Subject: OIL SEEPAGE FROM POWER STEERING OIL PRESSURE SWITCH	Bulletin No: 06-003/14
	Last Issued: 12/18/2014

2010-2015 CX-9

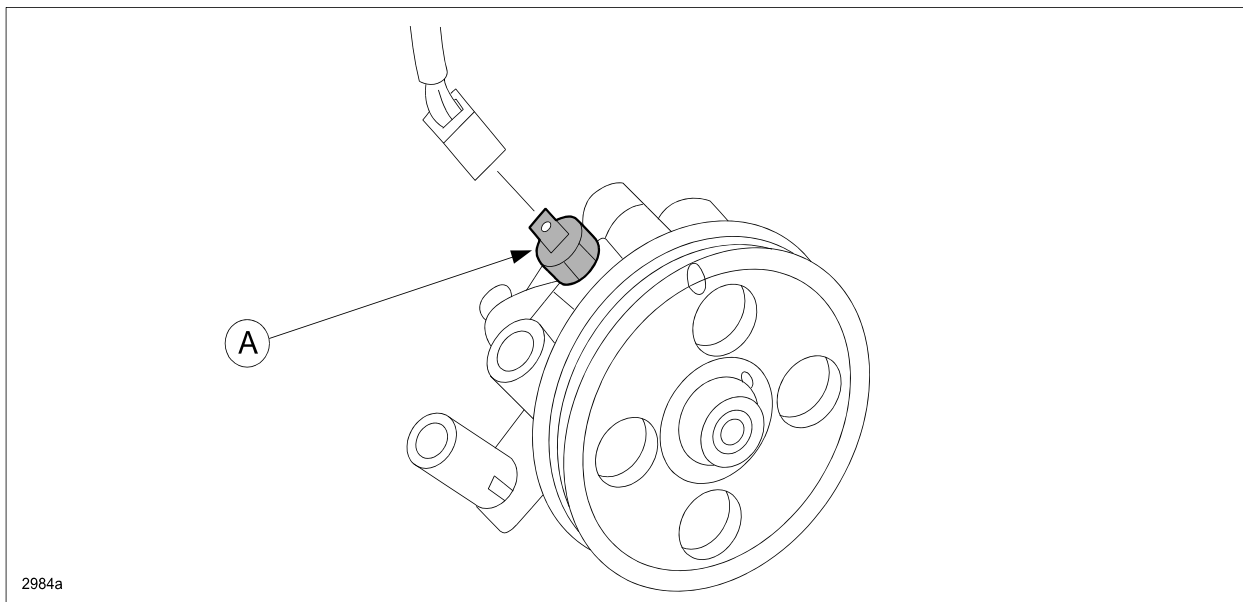
This may be due to oil seepage from the power steering oil pump pressure switch (A).

The oil seepage is caused by poor sealing of the oil pressure switch o-ring at low temperature. The shape and material of the o-ring has been changed to improve low temperature sealing performance.

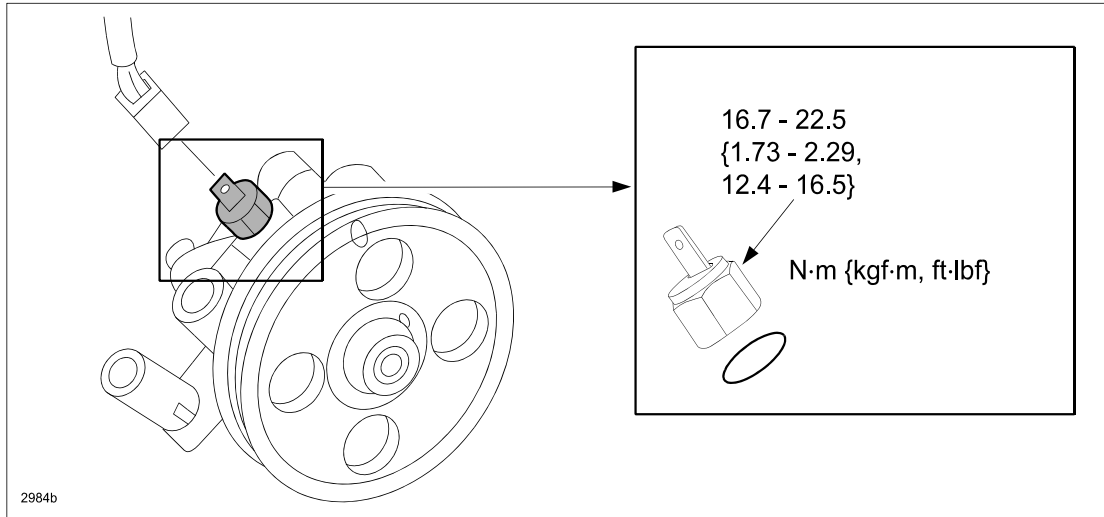
1. Verify the customer concern.
2. Replace the power steering oil pump pressure switch with a modified part according to the instructions on MS3 online or the Workshop Manual (section 06-14 POWER STEERING OIL PUMP DISSASSEMBLY/ ASSEMBLY).
